14. COA-055420-2019

2816 East Franklin Street

Commission of Architectural Review

STAFF REPORT

Figure 1. Sanborn Map, 1905

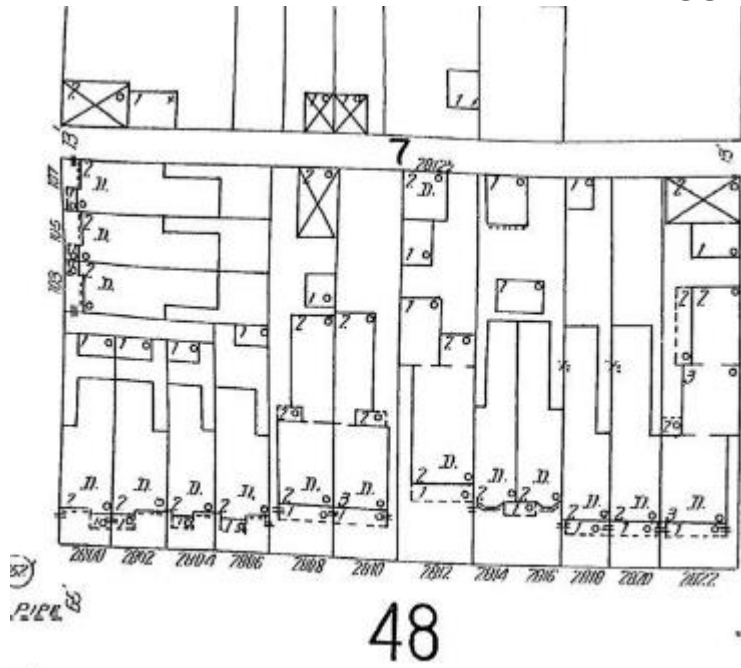
The mass of the proposed secondary building is smaller than the primary resource, and located at the rear. Sanborn maps indicate historically a one-story outbuilding has been present on the site since at least 1905. The Sanborn maps also indicate that, historically, two-story outbuildings have been located on the subject alley, though none are still standing.
